Kirby Morgan Dive Systems, Inc.®

Bulletin #9 of 2015. July 9, 2015

Change to Products

350-032 Main Tube is Replaced by 350-143 Main Tube

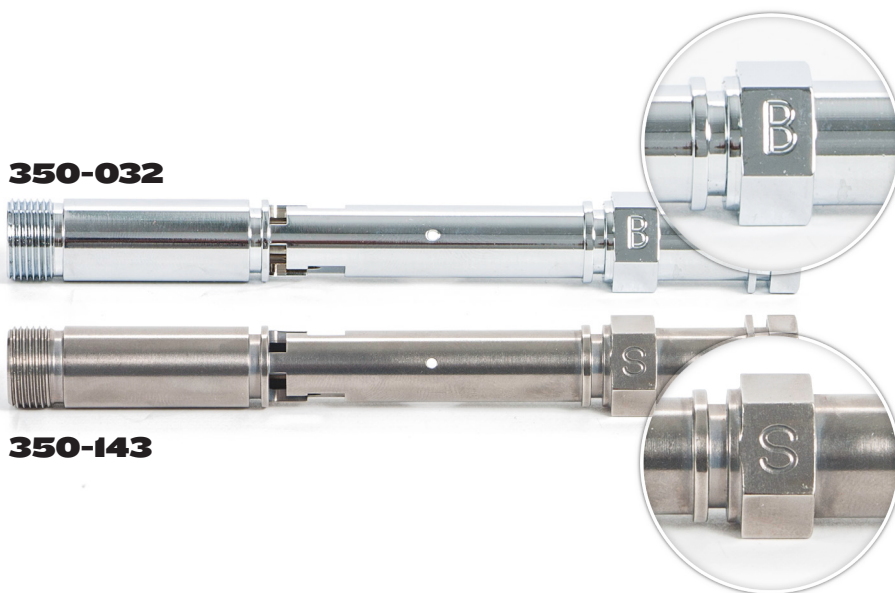
This bulletin is to inform you that the Main tube, 350-032, used in the balanced REX® & EXO-BR® regulators is now being manufactured of stainless steel (previously chromed brass). With this improvement it has been issued a NEW PART NUMBER, 350-143 Main Tube and is stamped with an "S" instead of a "B".
